Technical BULLETIN

SAFETY RECALL

ALL 2014 FZ09 MODELS

FACTORY MODIFICATION CAMPAIGN – Headlight Does Not Work

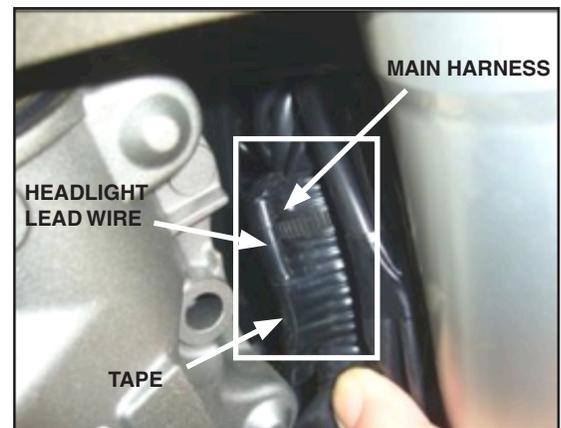
Yamaha Motor Corporation, U.S.A. has decided that a defect which relates to motor vehicle safety exists in 2014 FZ09E ("FZ-09") model motorcycles. In affected motorcycles, the headlight lead wire can be stretched when the handlebars are turned fully to the left or right. This is due to insufficient length of the headlight lead wire. If this happens repeatedly, the headlight coupler may disconnect from the headlight bulb or the headlight lead wire may break near the coupler. If this happens, the headlight would malfunction, which could result in the possibility of a crash with injury or death.

To correct this problem, Yamaha is initiating a Factory Modification Campaign. Affected units must have a headlight bulb sub-lead harness added to provide proper lead wire length.

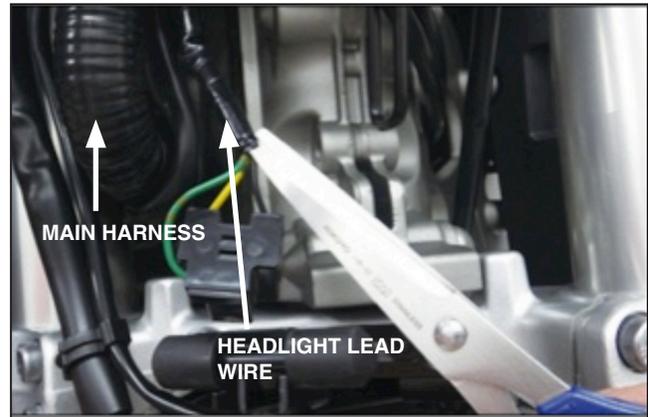
1. Cut and remove the vinyl tape which fixes the main harness and the headlight lead harness. Next, cut the tape covering the end of the protective cover of the headlight lead wires from the end. Discard the tape.

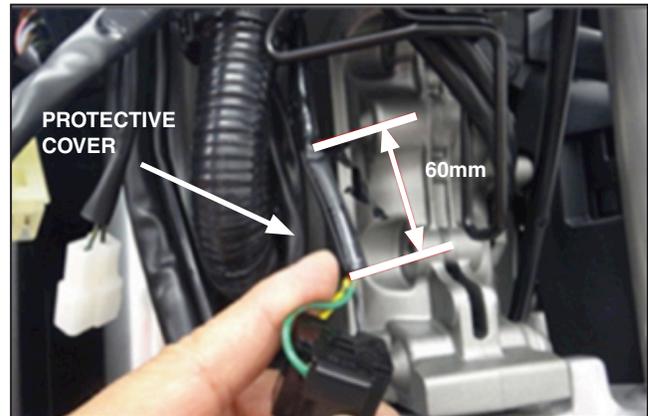
2. Split the protective cover up 60mm from the end (see adjacent photo). Then, also cut the protective tape on the headlight lead wires up 60mm from the end.

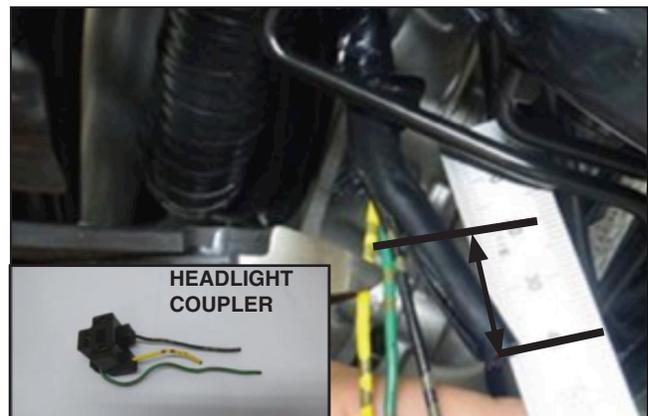
3. Using the end of the protective cover for reference, cut each headlight lead wire to the length shown below.

Yellow wire: 20mm
Green wire: 40mm
Black wire: 40mm

Discard the headlight coupler once the wires are cut.

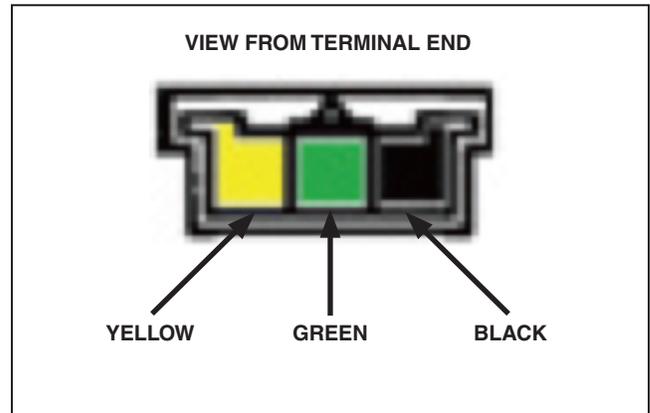
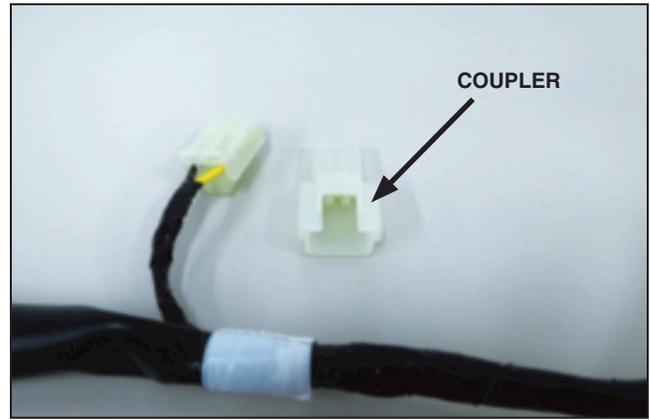
2. Remove the empty 3-pin coupler from the new wire sub-lead kit. Insert the terminals from step 1 into the coupler until it clicks and engages the catch. **NOTICE: After inserting, pull on the wire to check to be sure the terminal is locked in place.**

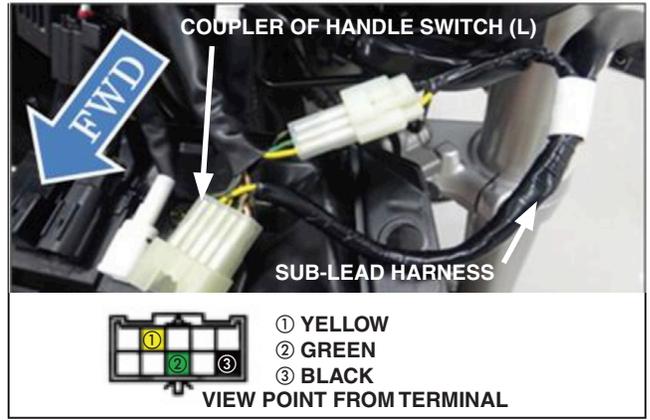
4. Insert each terminal end (yellow/green/black) of the sub-lead harness into the coupler for the left handle switch (L) until it clicks and engages the catch. **NOTICE: After inserting, pull on the wire to check to be sure the terminal is locked in place.**
5. Reconnect the 4 couplers disconnected in step 6 of *Modify the Headlight Lead Wire*.

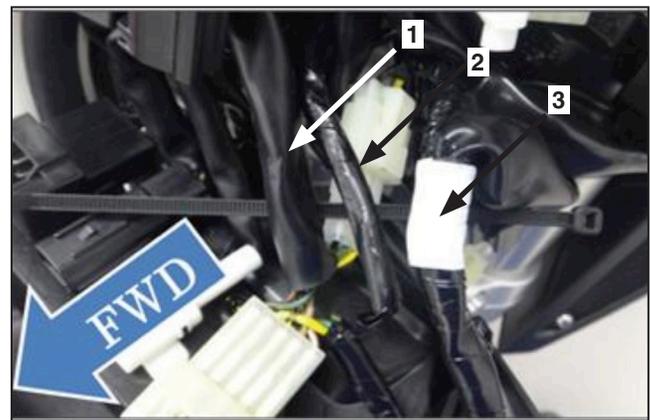
6. Band the wires together as shown with clamp (90465-10098-00).
 1. Sub-lead harness
 2. Old headlight lead harness (cut and taped)
 3. Left handle switch harness

Band Position

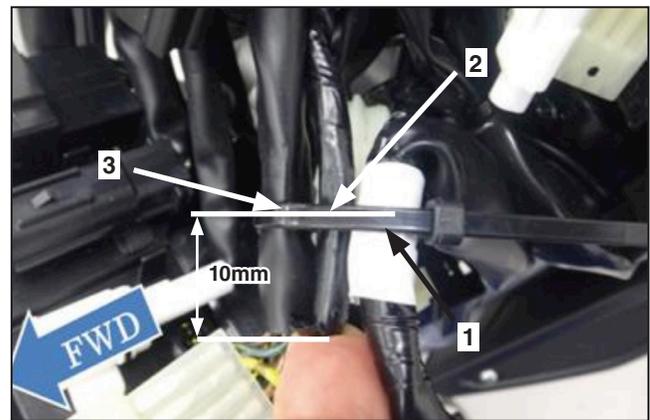
1. Center of the white tape
2. 10mm from the end
3. 10mm from the end of the protective cover

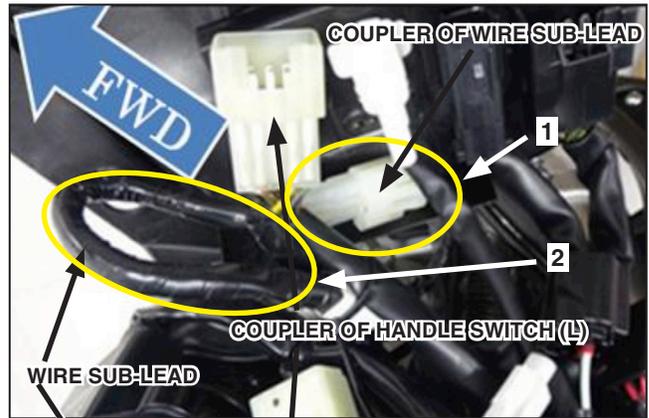
7. Route the lead wires as shown.
 1. Place the Sub-lead harness coupler in the vacant space under the coupler of the handle switch (L).
 2. Run the wires on the left side of the coupler for the handle switch (L).

Identification of the Modification

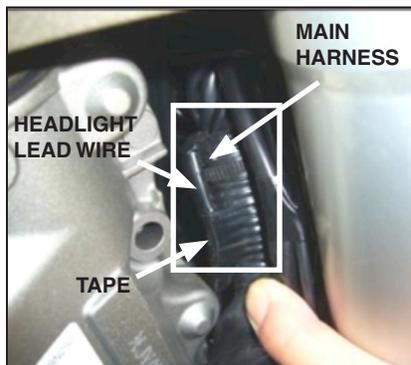
Non-modified Unit

Headlight lead wire is fixed to main harness with tape.

Modified Unit

Headlight lead wire is not fixed to main harness.
